Agenda Item: 7K Subject: Code for Canals Date: Dec 2/24

Agenda Item: 7 Subject: 592+582 Ranger Date: 12-2-24

Appeal of Departure Request 582 Ranger Lane & 592 Ranger Lane

**June Drawing Still
Did not Accurately
Reflect Conditions or
Compliance**

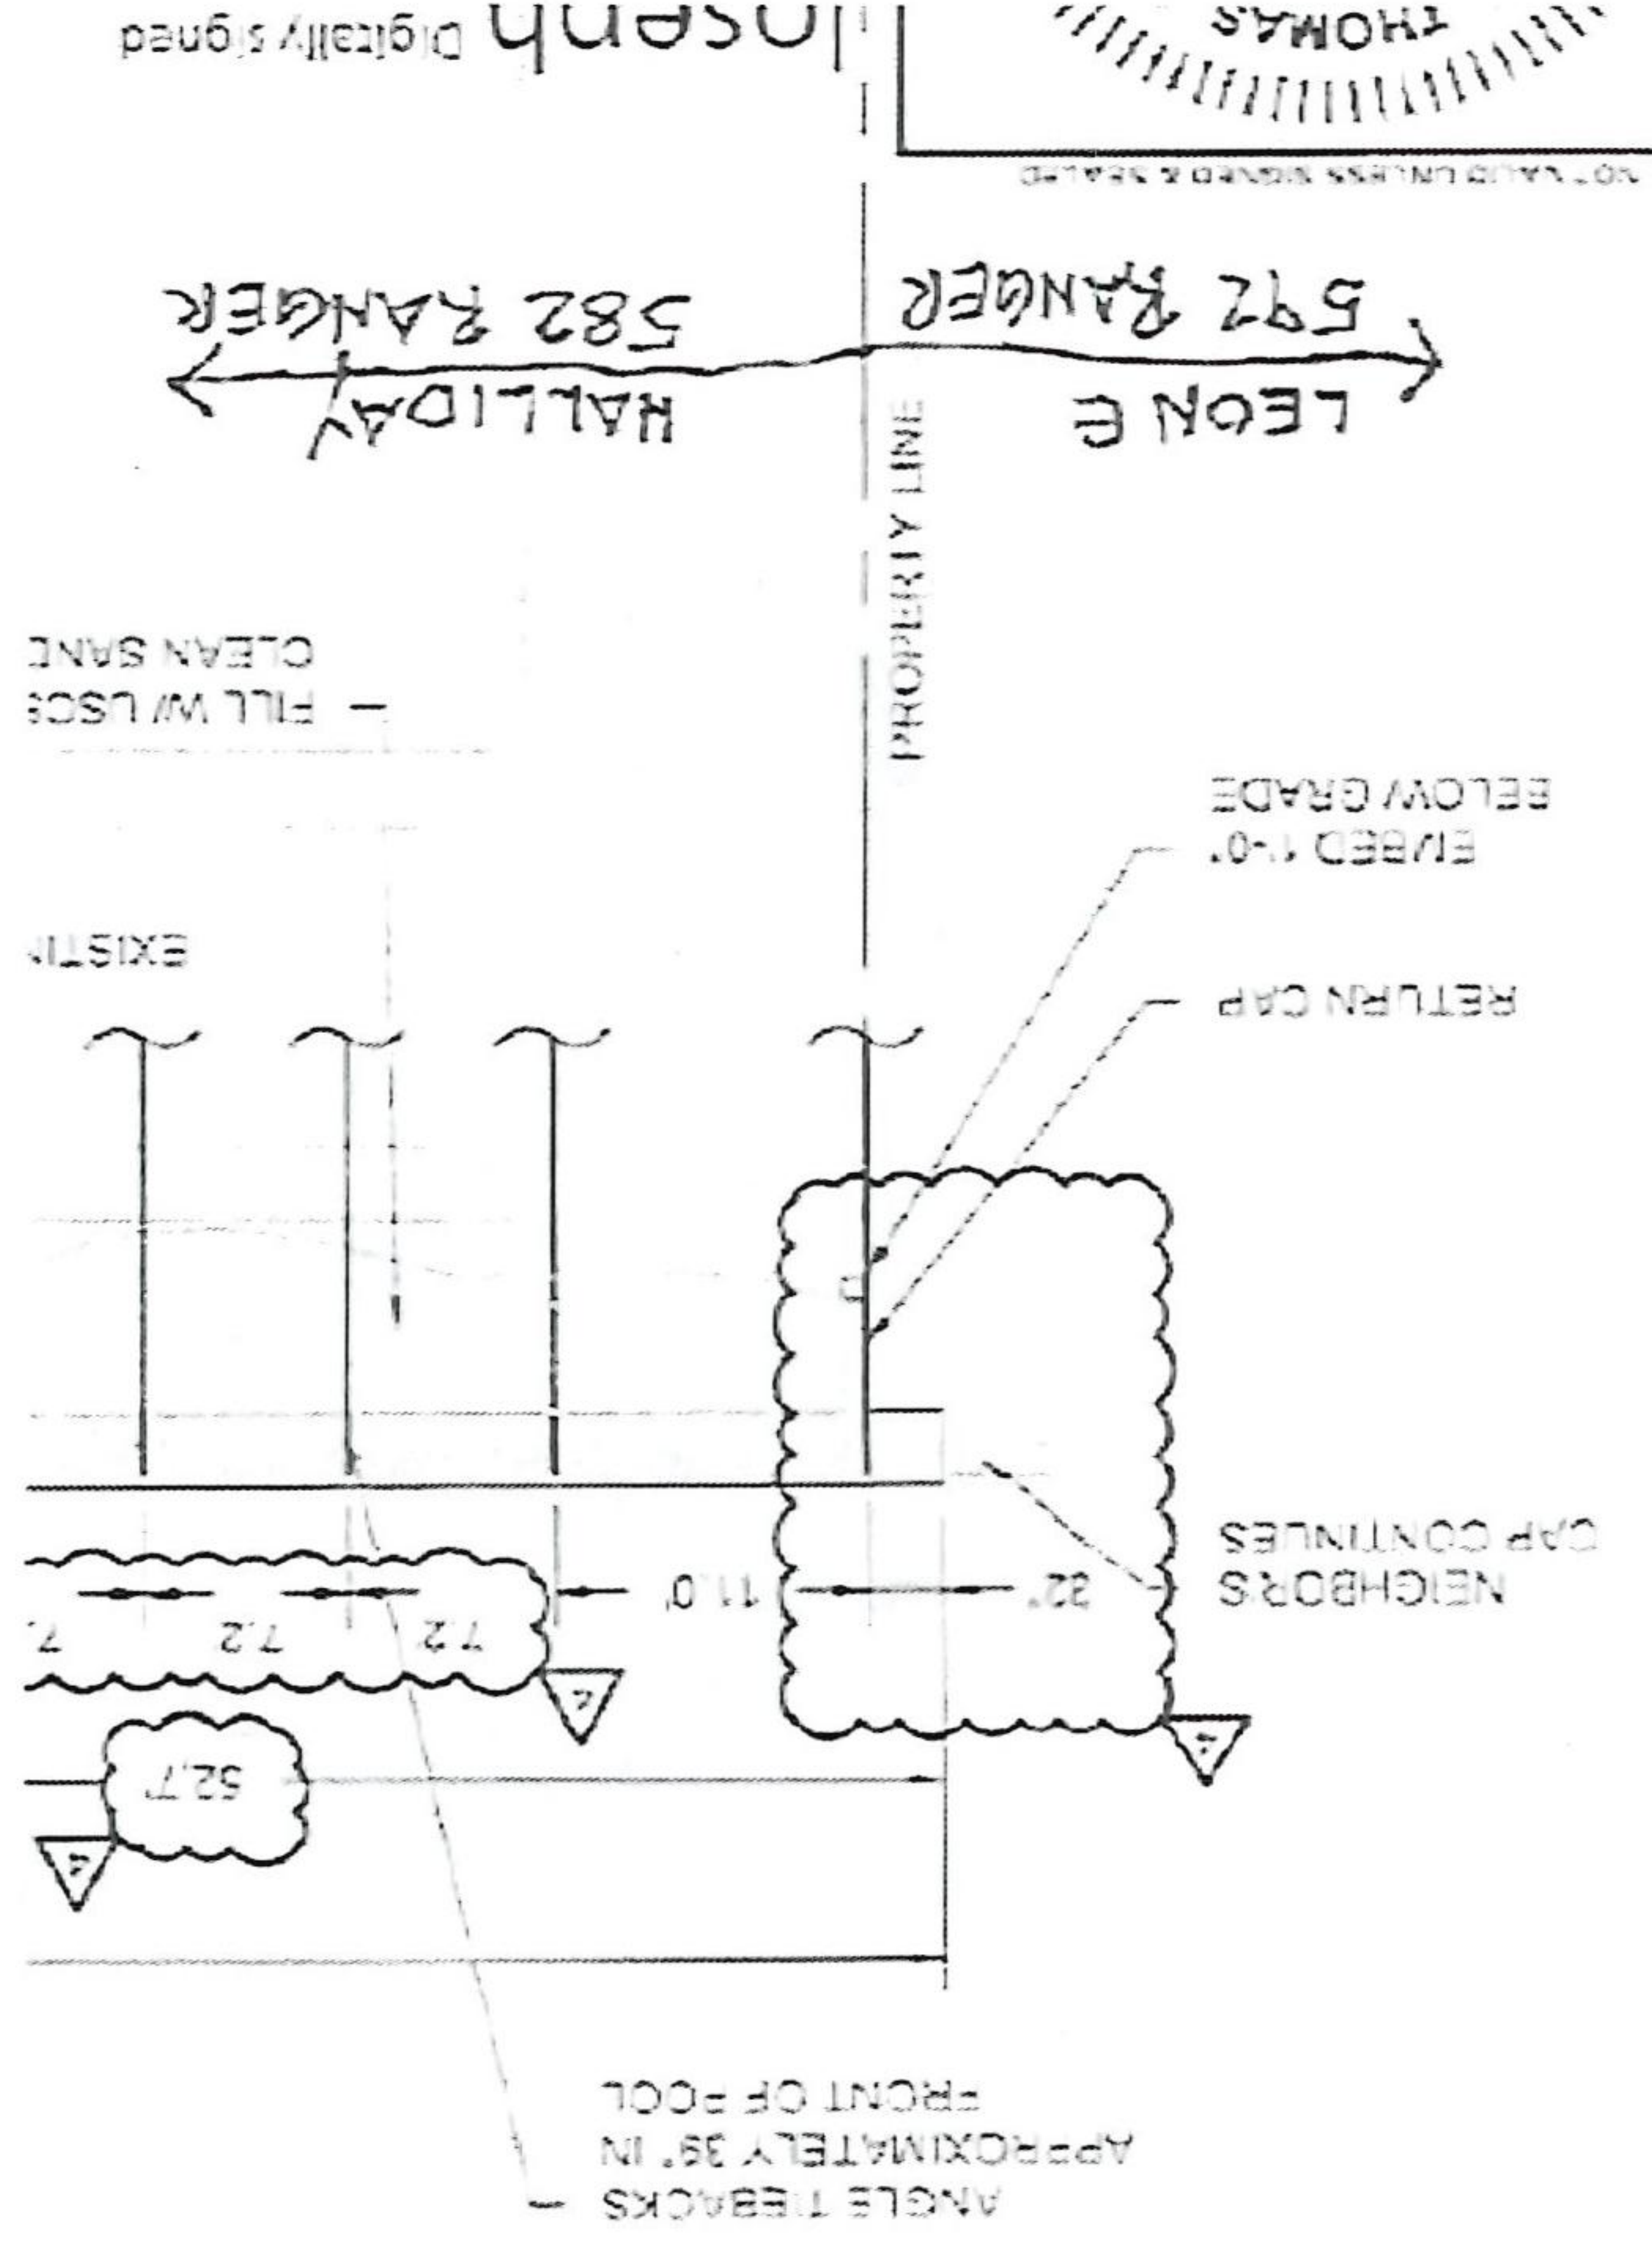
Depicts gap, but shows
"new" seawall face as
contiguous, not over 28"
in front of 592 seawall

May Drawing And GIS Show Pool Violates Canal Setback

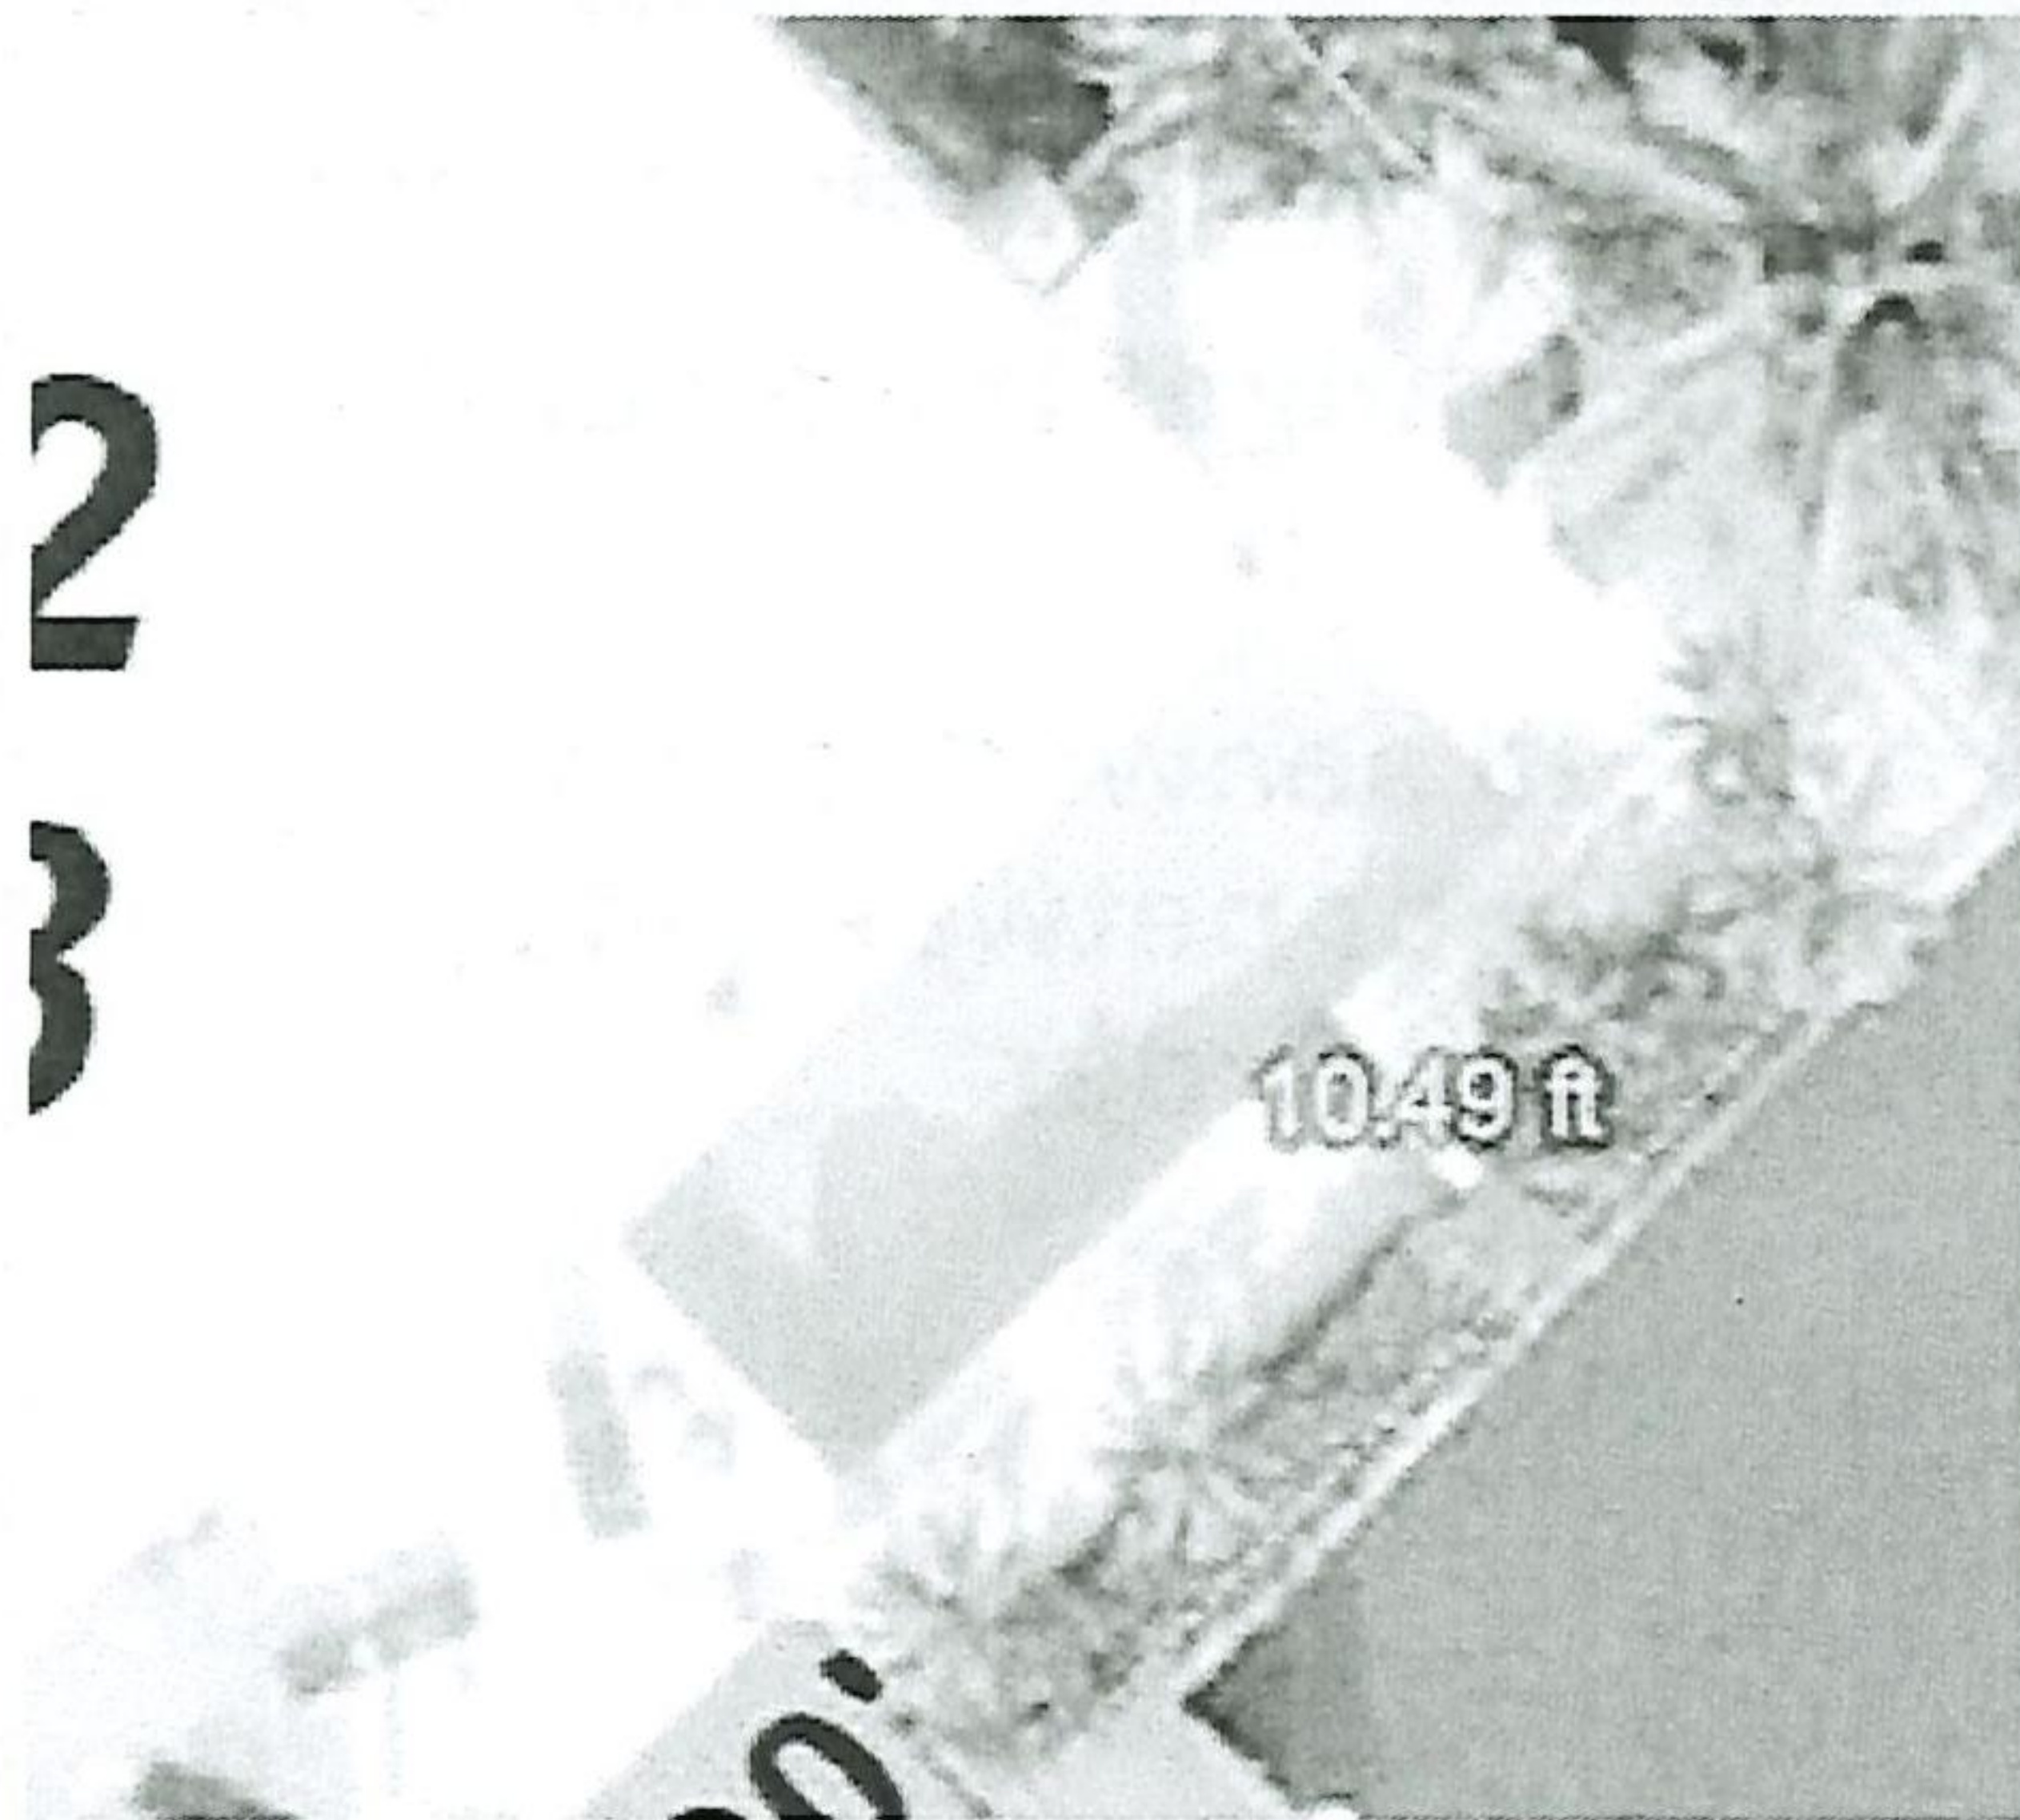
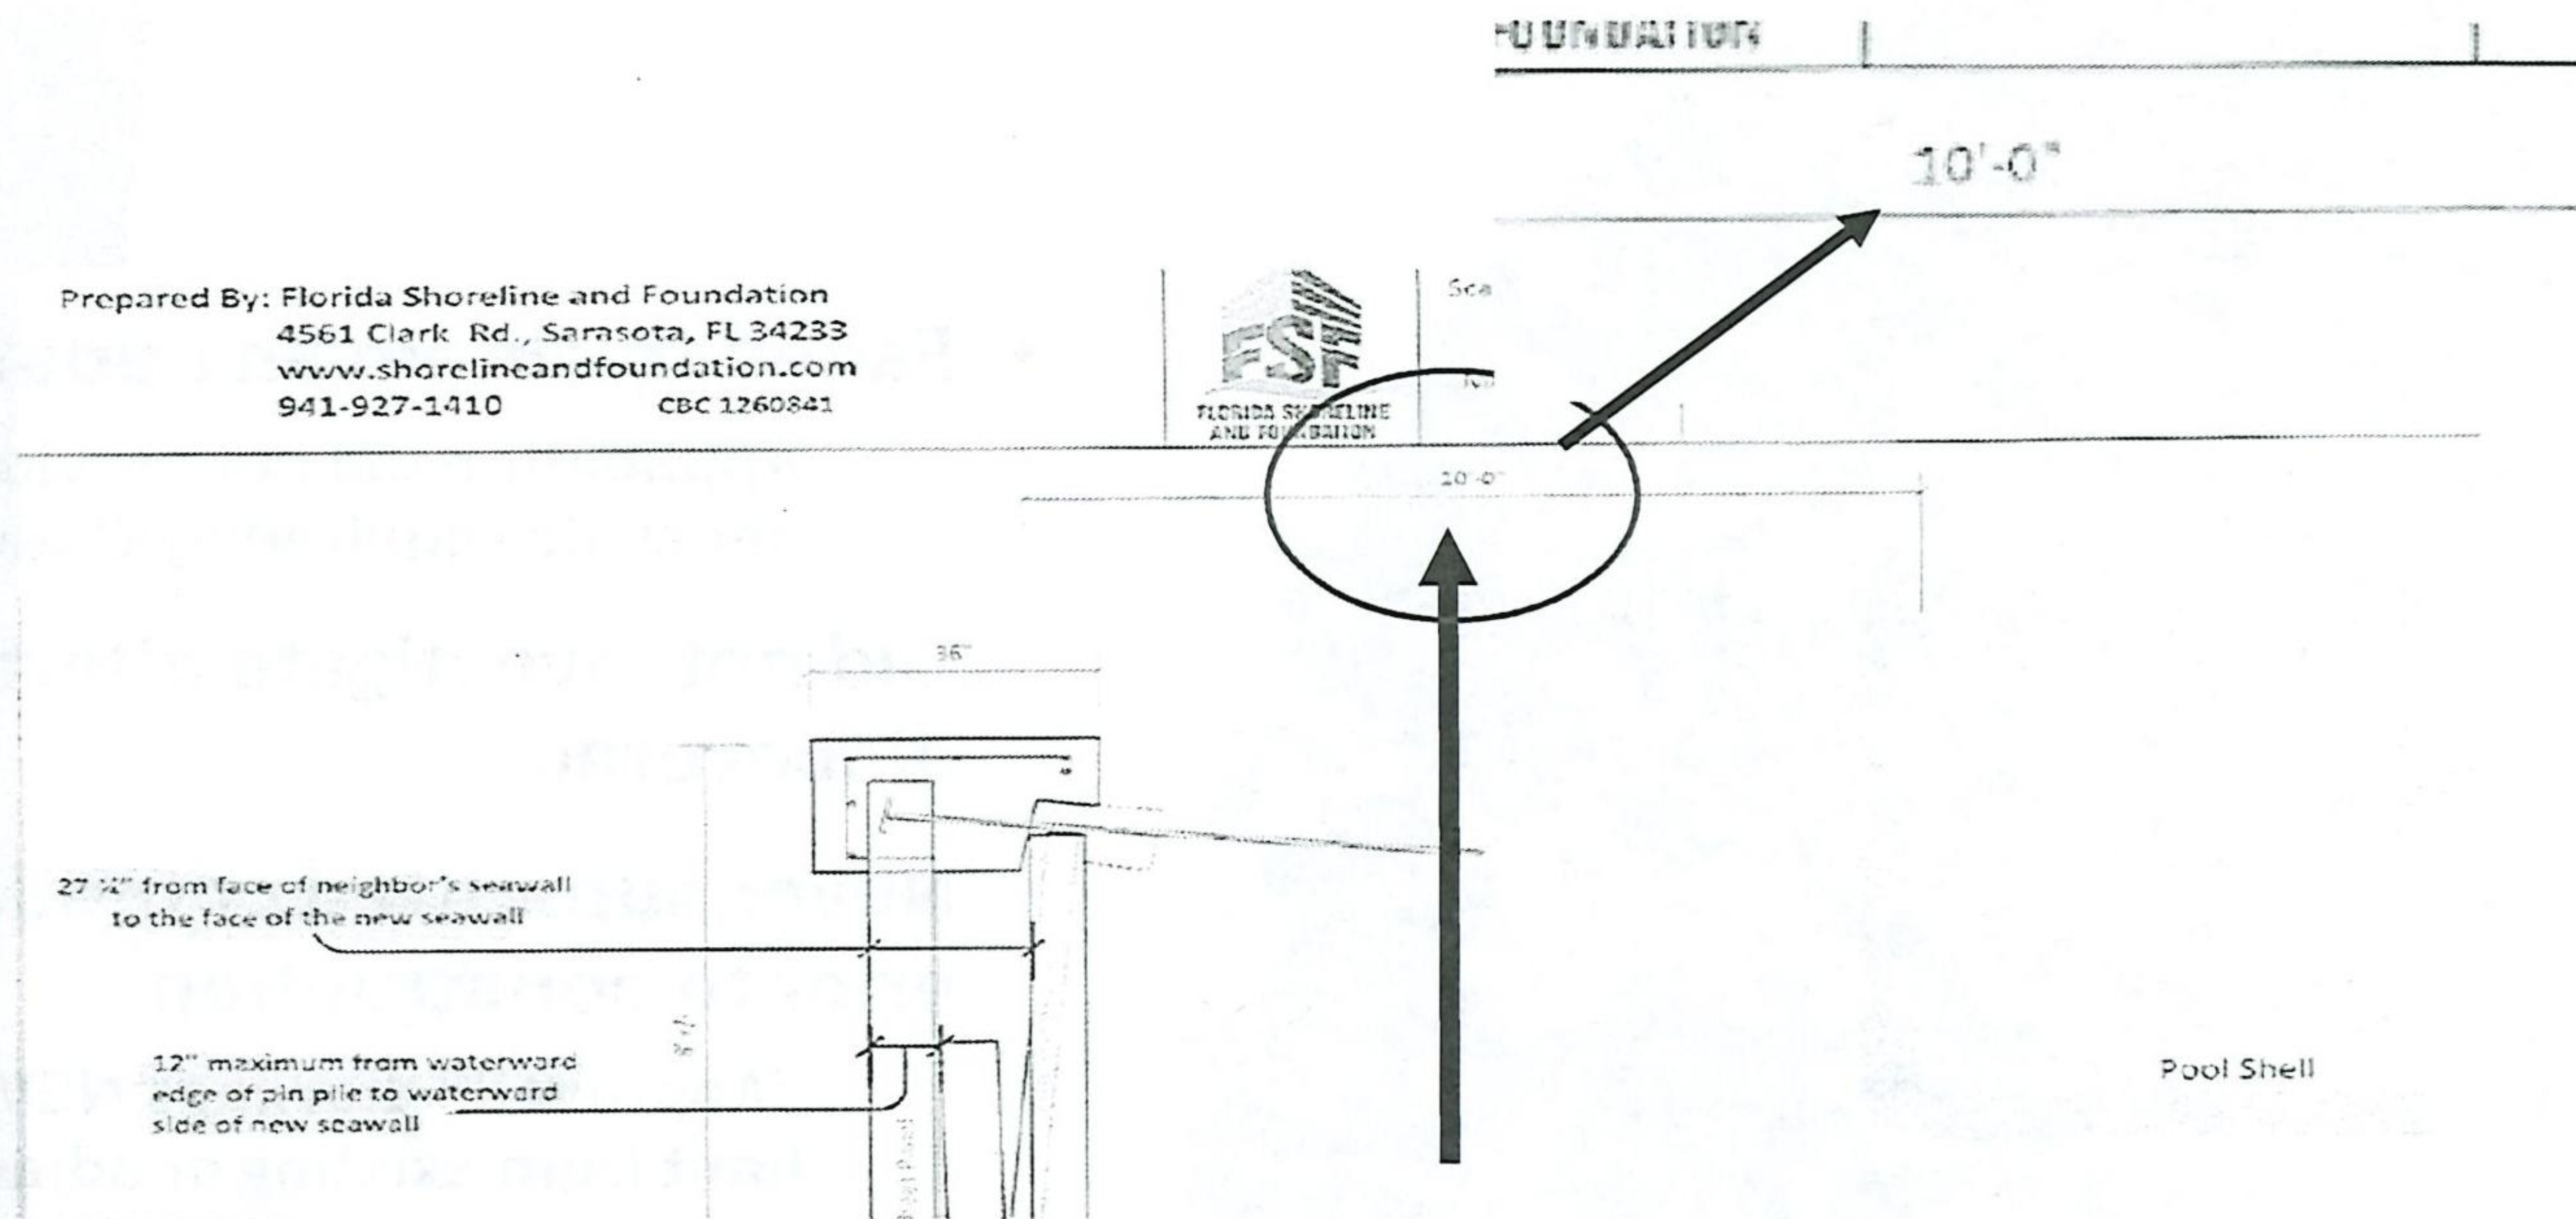
Pool Shell setback is 10' per Drawing and 10.5' based on PA GIS Aerial.
